# Transition to Step 1 and New Package Substrate for Select Virtex-5 LXT and SXT Devices

XCN07026 (v1.0.1) March 11, 2008

Product/Process Change Notice

Table 2: Summary of Affected Devices (with Example Ordering Codes)

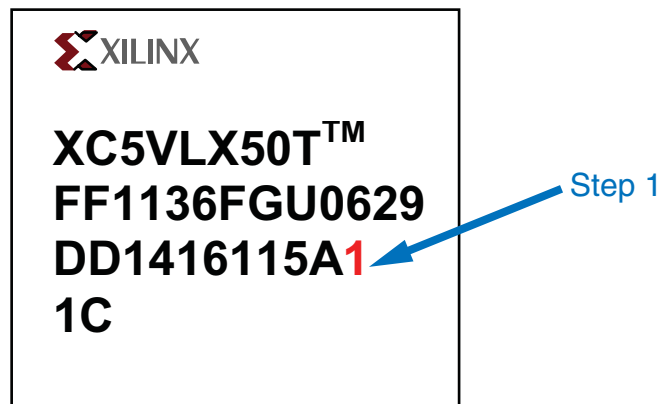
Table 2 summarizes the changes and example ordering codes for the affected LXT and SXT devices. This change applies to all speeds and grades for the devices listed in Table 2.
